Detailed Site Plan
Departure from Design Standards
Alternative Compliance
Dash In at Marlboro Pike #1552

DSP-21009
DDS-687
AC-21022

SUBJECT: Detailed Site Plan DSP-21009
Departure from Design Standards DDS-687
Alternative Compliance AC-21022
Dash in at Marlboro Pike

Figure 1: Site Plan

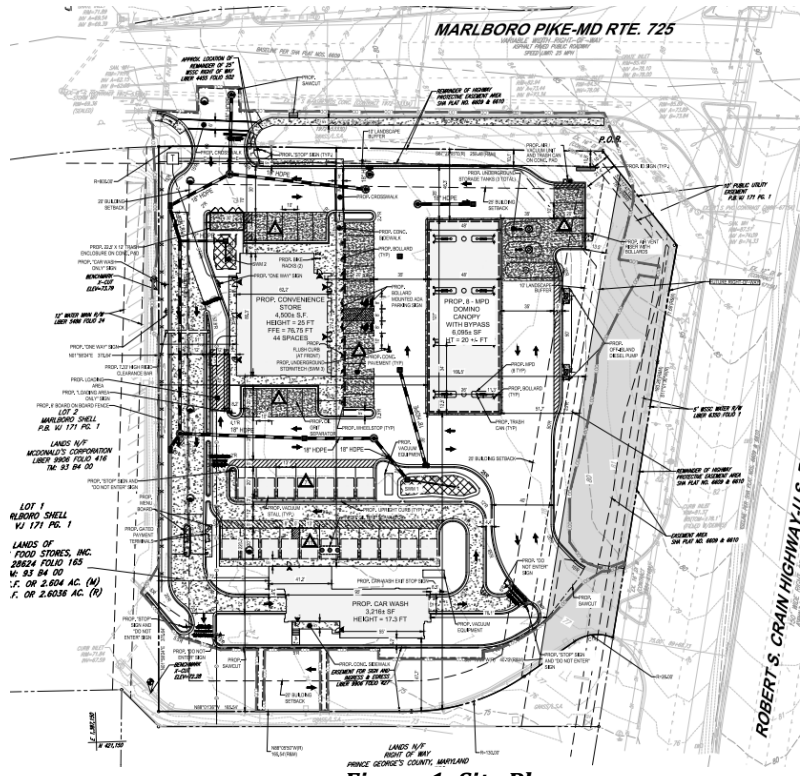
- c. Revise the sign legend to correspond to the signs on the site plan. Provide the same labeling convention for both the legend and the plan.
 - d. Label the area of Lot 1 on Sheet 4 of the DSP in square feet and acres.

- g. Provide the exact dimensions of the buildings on the site plan.

- h. Add the street connection width for MD 725 (Marlboro Pike) to the site plan.
- i. Revise the landscape plan to conform to Section 4.3 by removing one parking space to the east of the food and beverage store, widening the planting islands five feet, and adding a shade tree to each island.
